Product Change Notification: P-21-021092

HCR150 Relay

Studs_comparison

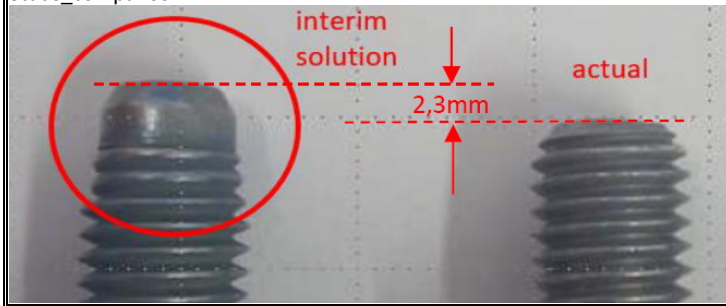
Dear customer, Due to the actual delivery situation on machined parts we are forced to use an alternative MATHread stud on or relays in order not to disrupt our production and deliveries. The geometry of the studs is very similar, the thread remains unchanged (M6) and we do not expect an impact in the cable assembly process at your side. The plating, load class and allowed torque are the same for both studs. The length of the regular stud is 9,6 mm while the alternative one is 9,9mm, the overall length of the alternative is 15,5mm instead of 13,2mm (the tip of the stud is beveled). This alternative component is already used on many versions of this product family produced at our facilities.
